Letter from Dr. Michael Peck to Senator
Barbara Boxer (January 22, 2015)

SUBJECT: Continued Failure of the United States Nuclear Regulatory Commission to Enforce Nuclear Safety Rules at the Diablo Canyon Nuclear Power Plant

Figure 1
Comparison of New Gounod Motions with the 1977 Hosgri and 1991 LTSP

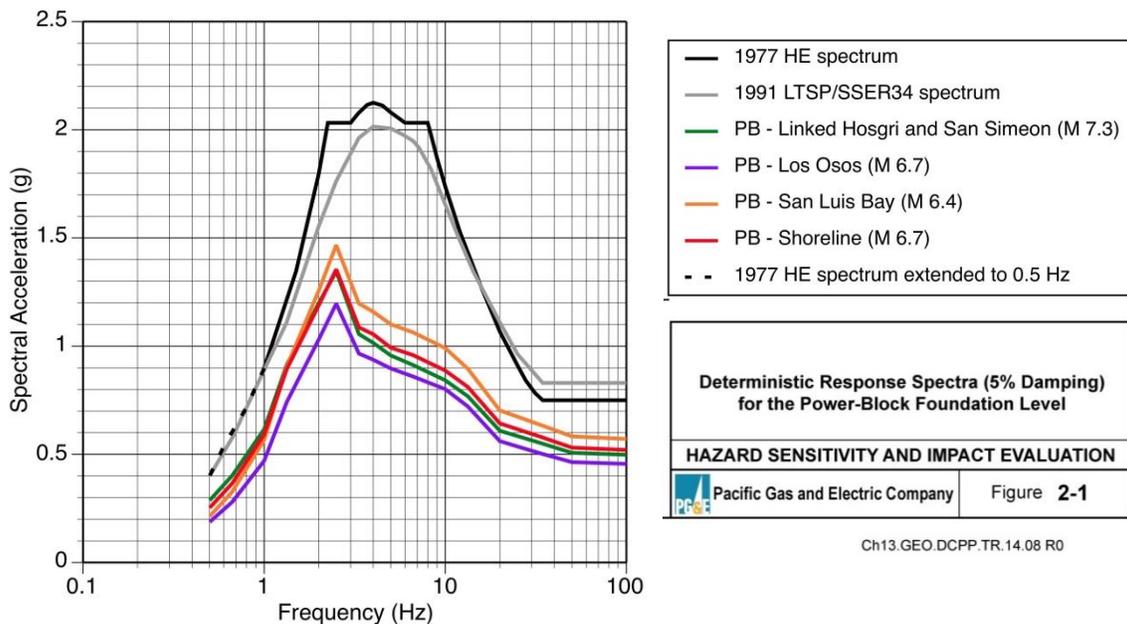
The 1977 Hosgri Spectrum was developed using a 145 km fault length. The new evaluation concluded that the Hosgri has a 171 km fault length.³⁸ The increase in fault length correlates to an increase in earthquake capability. Using CLB methods, the new "PB – Hosgri Linked Spectrum" (shown in green on Figure 1), should have exceeded the 1977 Hosgri Spectrum based on the increased fault length alone.

These new methods were also less conservative when compared to the "1991 LTSP/SSER 34 Spectrum." The 1991 Spectrum (shown on Figure 1) was based on a 7.2 M Hosgri earthquake with a 110 km fault length. The "PB – Hosgri Linked Spectrum" should have exceeded the 1991 LTSP/SSER 34 Spectrum based on the increased Hosgri fault length, if the LTSP Report methods and assumptions had been used.

Without making a judgment of the technical adequacy of the methods reflected in the spectra (Figure 1), these new methods clearly resulted in the analytical results to gain margin. In other words, PG&E's new methods predicted less seismic stress on plant equipment even though the earthquakes are now more severe. The 50.59 Rule required NRC approval of an amendment to the Operating License **before** PG&E was permitted to apply these less conservative methodologies and inputs to facility safety analyses.

Figure 2
Comparison of the Design, Double Design, and
Hosgri Seismic Inputs for Steam Generator
Qualification

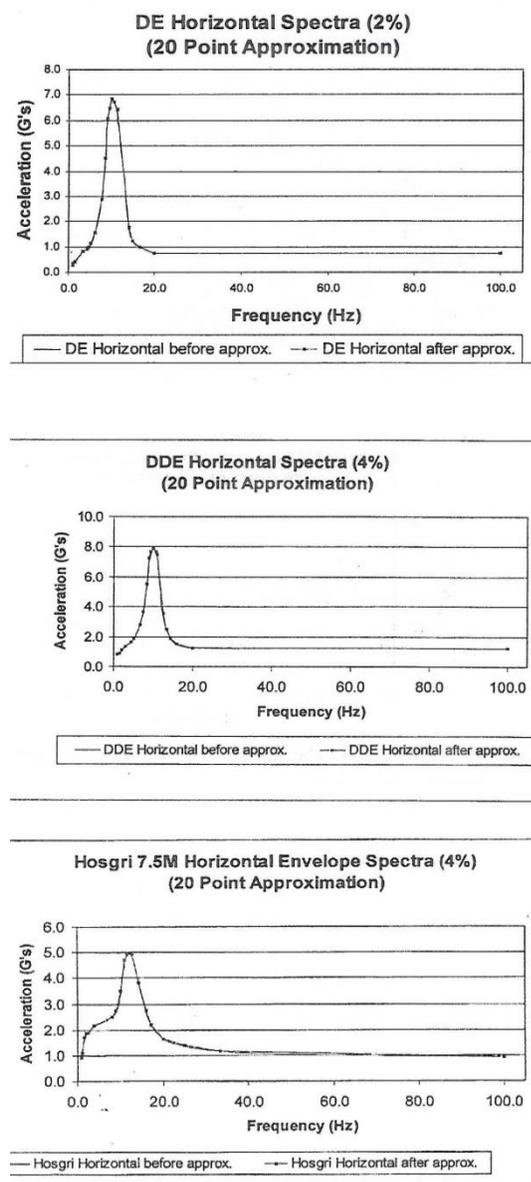
For example, consider qualification of the Diablo Canyon replacement steam generators. As with any plant modification, NRC regulations required that PG&E demonstrate that all Code requirements were satisfied before the reactors are restarted. This qualification process began with the Design, Double Design, and Hosgri ground motion spectra presented in the License Application. Using CLB methods and assumptions, engineers attenuated these seismic inputs to each steam generator. From these attenuation relationships, input spectra (Figure 2) were developed for each earthquake analysis. These spectra represent the levels of vibratory motion (acceleration/stress) affecting each steam generator as a function of harmonic frequency.

The next step in the qualification process was to add the seismic inputs (from Figure 2) to the load combinations specified by the CLB (Cases 1-3). The Double Design load combination (Case 2) results in the highest component stress levels. However, Code acceptance limits are different for the Design (OBE) and the Double Design (SSE)

The Design and Double Design seismic analyses provide very little margin to Code limits, not only for the steam generators but also for other Class 1 components. The unavailability of margin is due to the unusually large seismic loading associated with the original Design earthquake (0.2 g). This affect was also seen in calculations supporting qualification of the replacement reactor heads. For the new heads, the initial design exceeded Code allowable stress on some components for the Design and Double Design Earthquake cases, but not for Hosgri. As a result, PG&E was required to obtain an amendment to the Operating License to allow less conservative safety analysis inputs to complete the reactor head qualification.⁵⁴ The FSAR includes many examples where PG&E to omitted to perform Hosgri qualification calculations based on the much higher seismic loading represented by the Double Design analysis.

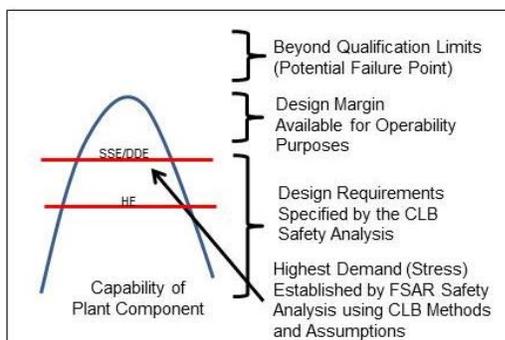
Figure 3a shows the design capability of the component (blue curve) and the level of demand (seismic stress) that the component must be capable of meeting for the Double Design and the Hosgri (red lines) evaluations. As demonstrated with the steam generators, Double Design places a higher demand on the component than the Hosgri. The area above the SSE/DDE demand but below the blue component capability curve is the design margin available for use in operability evaluations.

Figure 3b
PG&E's Use of Hosgri as Alternate Method for Operability

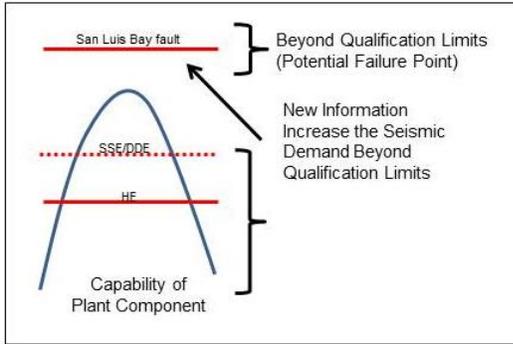
Figure 3.b shows that the San Luis Bay fault (new seismic information) places a higher demand on the component, exceeding the seismic qualification limit. Since the new demand is greater than available engineering margin, the licensee should have declared the component inoperable and applied the Technical Specification required remedial action (reactor shutdown).

PG&E used the Hosgri as an alternate method for demonstrating that the component was operable for the SSE. The operability evaluation stated that because the new San Luis Bay ground motions were less than those used for 1977 Hosgri, then the component was still operable for the Double Design earthquake, irrespective of the actual demand on the component.

PG&E's approach was problematic for two reasons. First, as shown with the steam generator example, seismic qualification is much more involved than just comparing ground motions. The fact that component remained qualified for the Hosgri did not mean that the SSE safety analysis was also satisfied. In fact, in this example the San Luis Bay earthquake (Double Design methods) far exceeded the capability/qualification of the component. Second, the required operability benchmarking would have clearly shown that the Hosgri, as an alternative method, would under-predict the required seismic stress placed on the component when compared to the Double Design methodology.

Figure 3c
PG&E Redefined Safety Analysis Limits by Changing Methodology and Assumptions

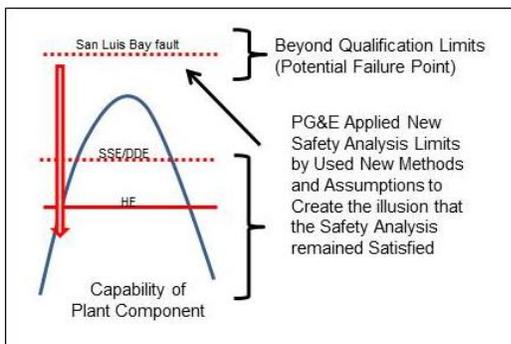
Figure 3.c illustrates the approach PG&E took for 2014 reevaluation. This new information indicated that the San Luis Bay fault also exceeded the Hosgri. PG&E used new ground motion prediction equations and inputs to reduce the amount of seismic energy that was considered to attenuate from the fault to the site. PG&E concluded that the component was operable because these new methods resulted in ground motions that appear less than the 1977 Hosgri Spectrum. Similar to the 2011 operability evaluation, PG&E's new methods inappropriately created the appearance of analytical margin while the actual new seismic loadings exceeded the qualification limits for the component.
